Re: Turkey Point Units 3 and 4  
Docket Nos. 50-250 and 50-251  
Response to NRC Reactor Systems Branch Request for  
Additional Information Regarding Extended Power Uprate  
License Amendment Request No. 205

RESPONSE TO NRC REACTOR SYSTEMS BRANCH (SRXB)  
RAI REGARDING EPU LAR NO. 205

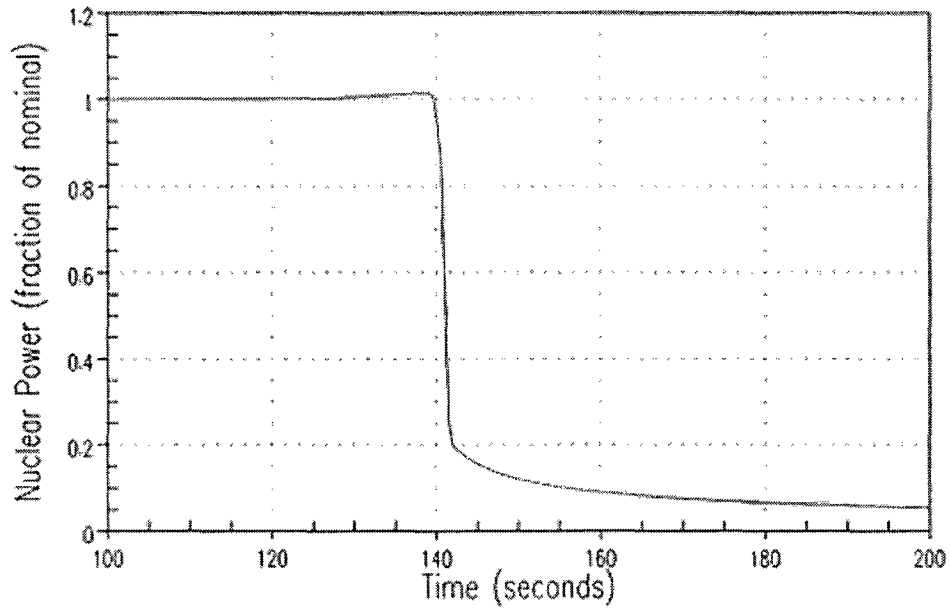
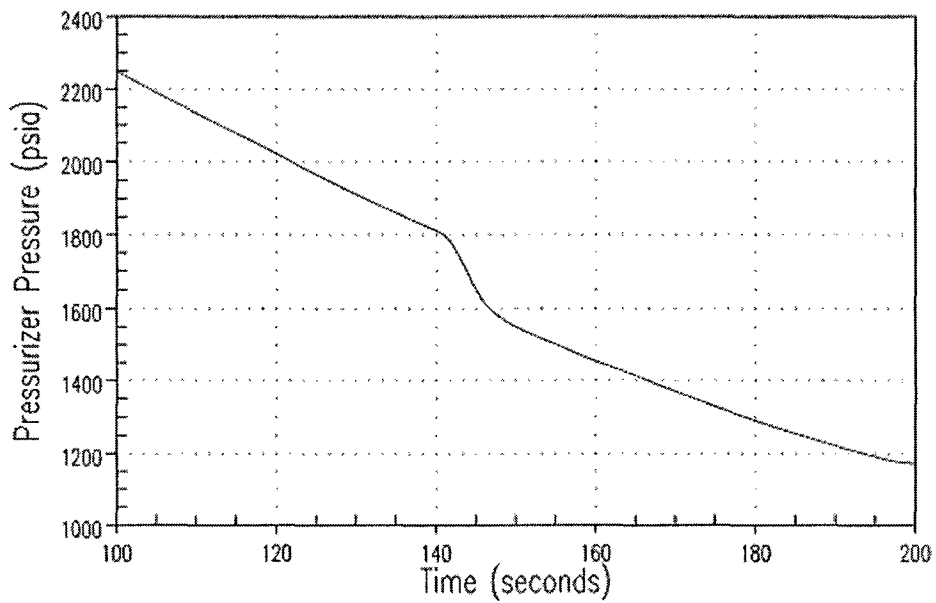
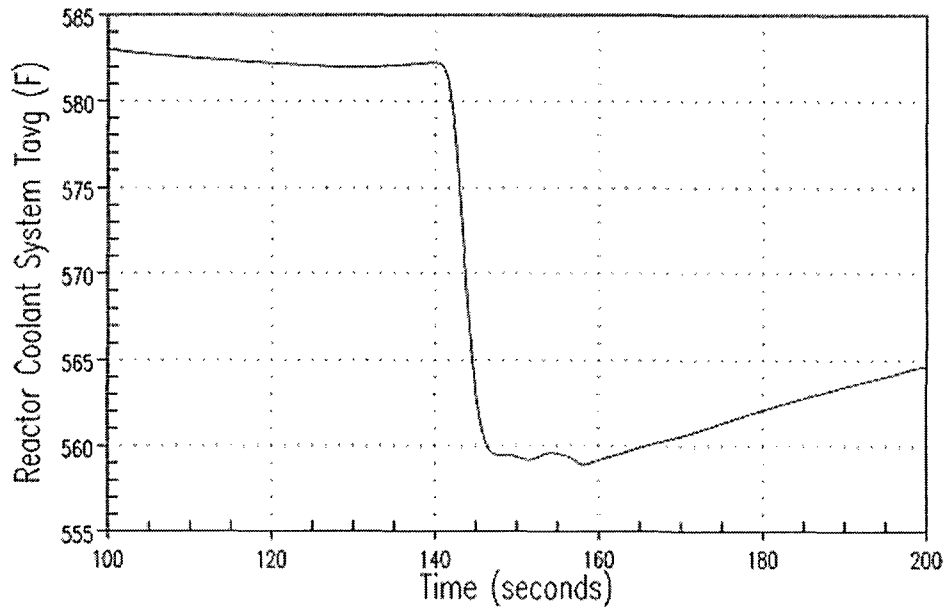
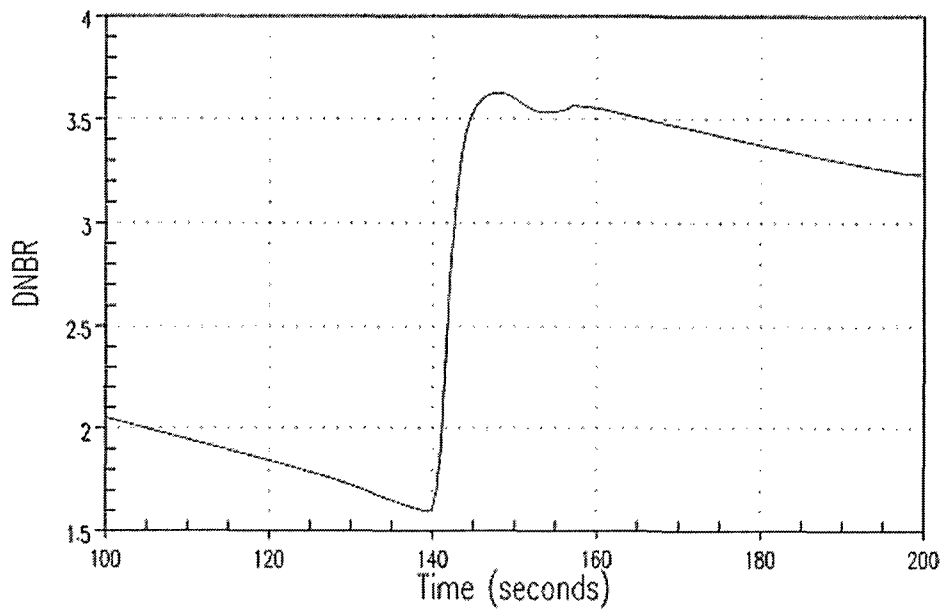
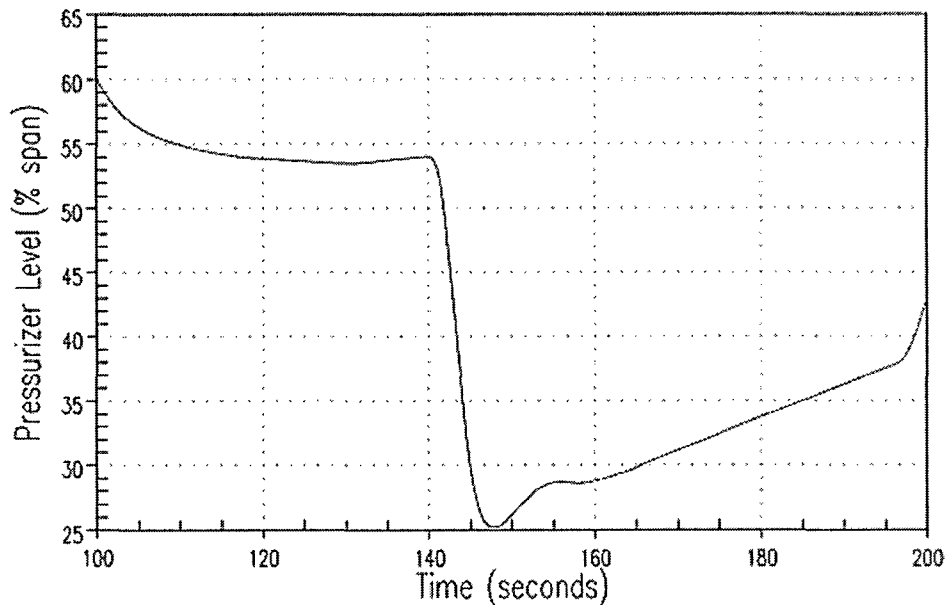
**SRXB-2.3.1 In the Turkey Point Nuclear (PTN) Final Safety Analysis Report (FSAR) Chapter 3, "Reactor," Section 3.1, "Design Basis," it is stated, "the Reactor Control and Protection System is designed to actuate a reactor trip for any anticipated combination of plant conditions, when necessary, to ensure a minimum Departure from Nucleate Boiling (DNB) ratio greater than or equal to the DNBR limit of the applicable DNB correlation."**

**The equation for the overtemperature delta-T (OTΔT) trip setpoint includes a differential pressure compensation term, which adjusts the trip setpoint based on deviations from the nominal reactor pressure. The setpoint is lowered when the reactor pressure is less than nominal, because a lower pressure decreases the subcooling margin. It is necessary to validate the DNB-protective function against both transients that increase the reactor heat flux, such as rod cluster control assembly withdrawal errors, and transients that reduce reactor pressure, such as a spurious power-operated relief valve or safety valve opening.**

**While in your response to RAI SRXB-1.3.29 asserts that the OTΔT trip provides the requisite protection, it is without a valid safety analysis on which to base this assertion. Demonstrate that this claim is true. A supporting analysis is necessary in order to conclude that the trip setpoint proposed for TS 2.2, Functional Unit 5, has been "so chosen that automatic protective action will correct the abnormal situation before a safety limit is exceeded," consistent with the requirement promulgated by 10 CFR 50.36(c)(1)(ii)(A).**

The calculated percent margin to minimum DNBR is 13.6%. A time sequence of events table is presented below in Table SRXB-2.3.1-2. Additionally, the transient plots for this analysis are provided in Figures SRXB-2.3.1-1 through SRXB-2.3.1-5 below. Note that a steady state run of 100 seconds preceding the transient has been removed for clarity. The final 100 seconds of transient time is plotted below.

The results of the RCS Depressurization analysis confirm that the OT $\Delta T$  trip provides adequate protection during an RCS Depressurization transient by demonstrating that the minimum DNBR safety analysis limit is not violated.
